Harnett County Department of Public Health Site Sketch

Property Location: 423 Mill Bend Dr. (Rawls Ch. Rd. - SR 1415)

Subdivision Olde Mill Village

Lot # 40

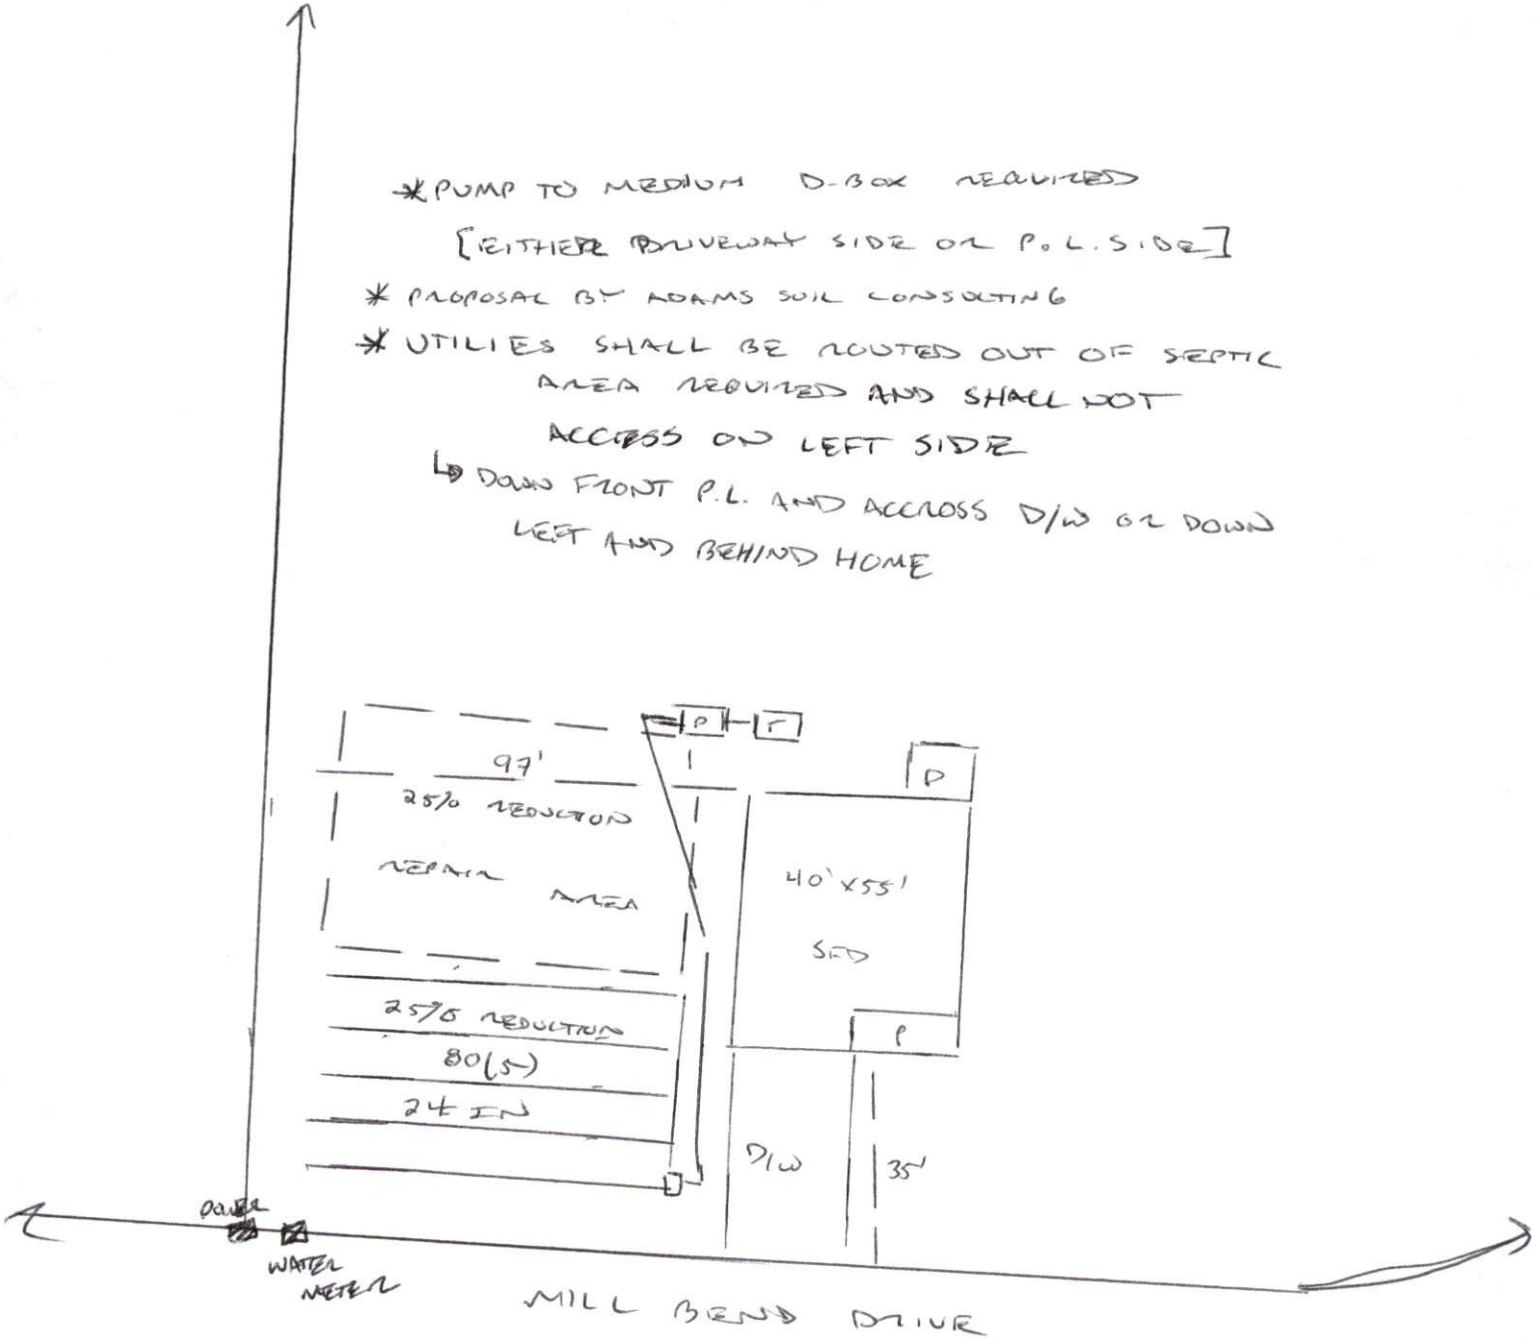
- * PUMP TO MEDIUM D-BOX REQUIRED
[EITHER DRIVEWAY SIDE OR P.O. SIDE]
- * PROPOSAL BY ADAMS SOIL CONSULTING
- * UTILITIES SHALL BE ROUTED OUT OF SEPTIC AREA REQUIRED AND SHALL NOT ACCESS ON LEFT SIDE
- ↳ DOWN FRONT P.L. AND ACROSS D/W OR DOWN LEFT AND BEHIND HOME
